Reversion History:

ARESCOM

ND 1760

MOTOROLA MPC850 MAIN BOARD

ARESCOM			
Title			
ND 1760			
Size	Document Number		Rev
	ADSL PHY CONNECTOR		4.0
Date:	Wednesday, August 08, 2001	Sheet	8 of 9

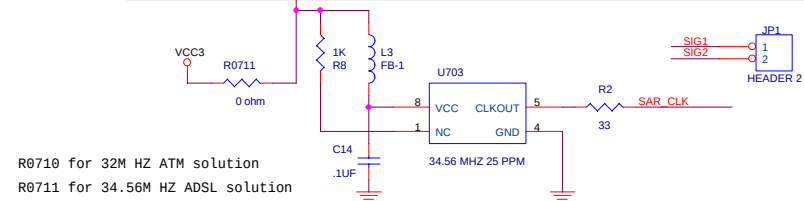
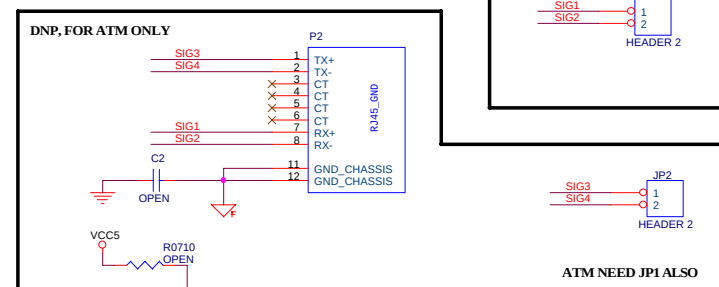
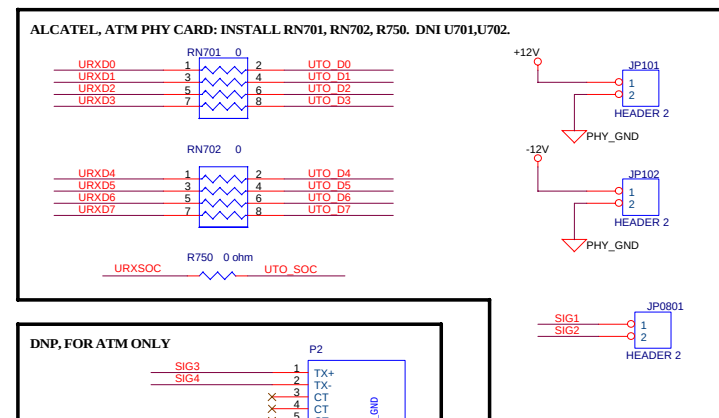
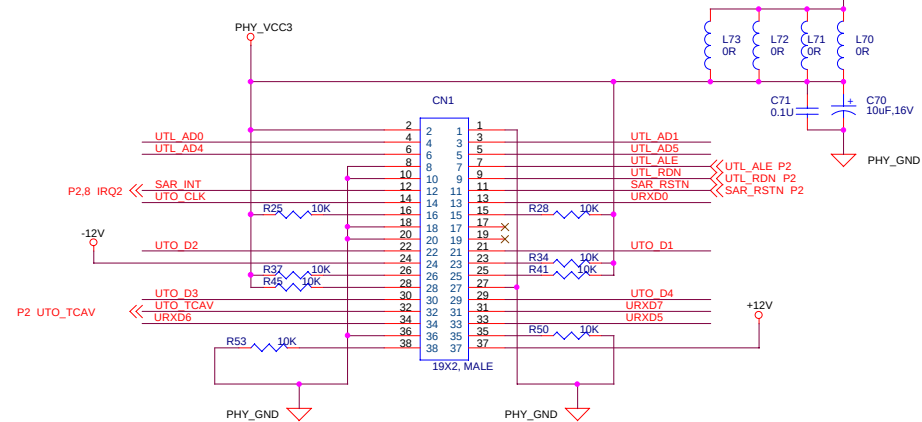
EMI improvement:
Add L5,L6,L7 and L8.
C1 change from 0.01uF to 0R.
C20,C22 change from 30pF to 15pF.

EMI improvement:
L20 to L25 and L70 to L75 change from FB-1 to 0R.
